COPTER ILS Y OR LOC Y RWY 6, AMDT 2

PRB RESULT: RETURN FOR REWORK

COMMENTS:

COPTER ILS Y or LOC Y RWY 6  
TETERBORO (TEB)

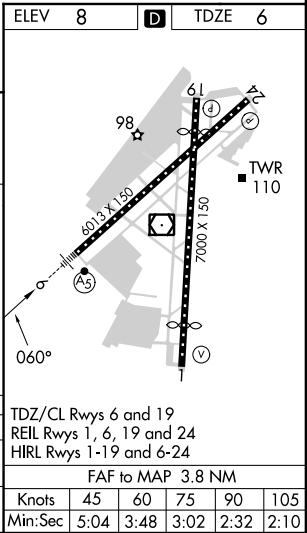
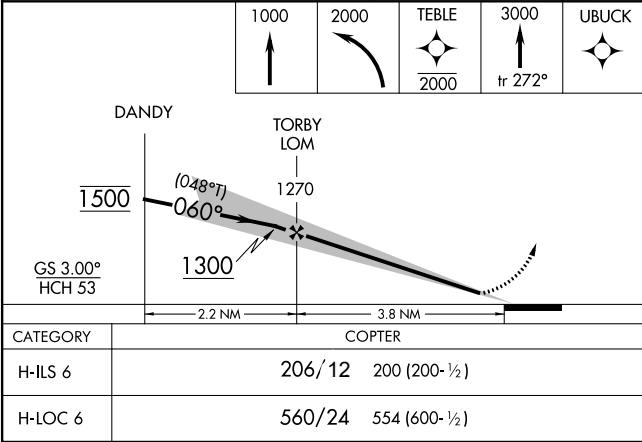
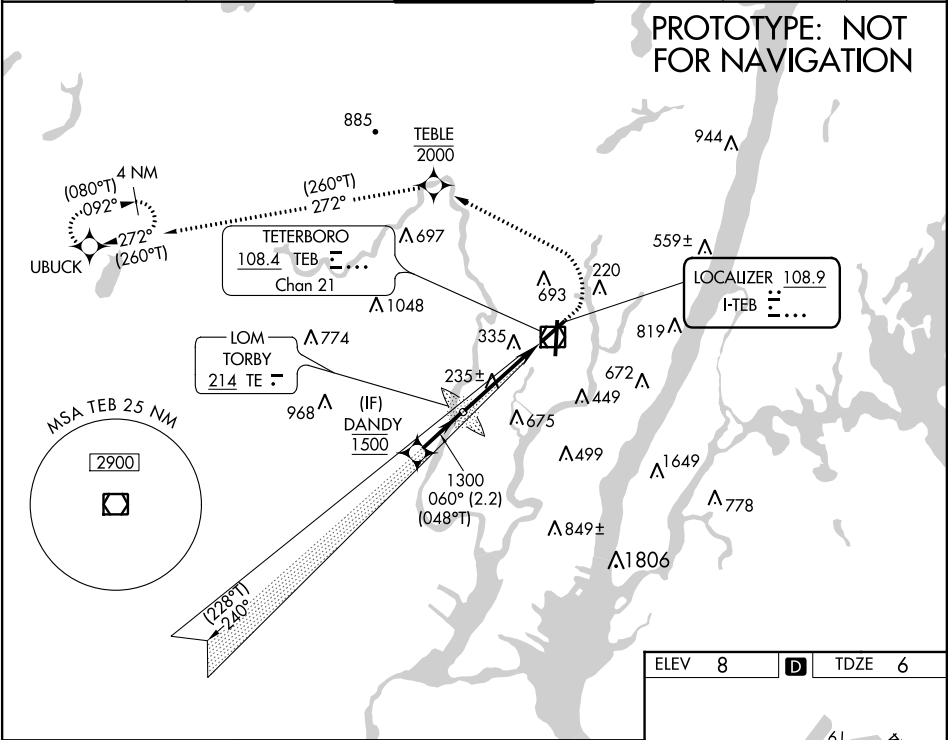
1. FLIGHT VALIDATION DOCUMENTATION MISSING
2. 8260-3 TERMINAL ROUTES: ADD PBN MISSED APPROACH (IAW 8260.19I, 8-6-4.A(6)(A).
3. 8260-3 TERMINAL ROUTES: DANDY TO TORBY LOM, TARGETS DETERMINES 60.07 VS 60.16.
4. 8260-2: UPDATE DANDY, TERBLE AND UBUCK TO REFLECT FIX TYPE: RADAR (IAW 8260.3E 2-9-4).

1. 8260-9 INTERMEDIATE: VERIFY TERRAIN (AIRSPACE) COORDINATES. CURRENT COORDINATES ARE IN THE FINAL SEGMENT.
2. 8260-2 UBUCK, REMARKS: CHANGE "EVELUATION" TO "EVALUATION".
3. VERIFY FPT HAS CONFIRMED ATC HAS THE LOCATION AND ALTITUDES OF THE WAYPOINTS IDENTIFIED IN COMMENTS #4 ABOVE.

1. FC SAT PC added.
2. 8260-3 MA ADDED.
3. Final Approach Course (FAC) along the extended final from DANDY to TORBY LOM is 60.16. TARGETS apparently evaluated this segment as WP to WP instead of conventional.
4. Coordinated with ATC for DANDY to be defined as a Radar fix in addition to a WP. On a case by case basis for ATC traffic flow (or upon request), ATC will vector aircraft to final via DANDY. DANDY is already depicted on the ATC radar video map. It was inadvertently removed from the 8260-2 during the previous submittal for this chart date. TEBLE AND UBUCK are WPs for the RNAV missed approach and are not required to be defines as Radar fixes.
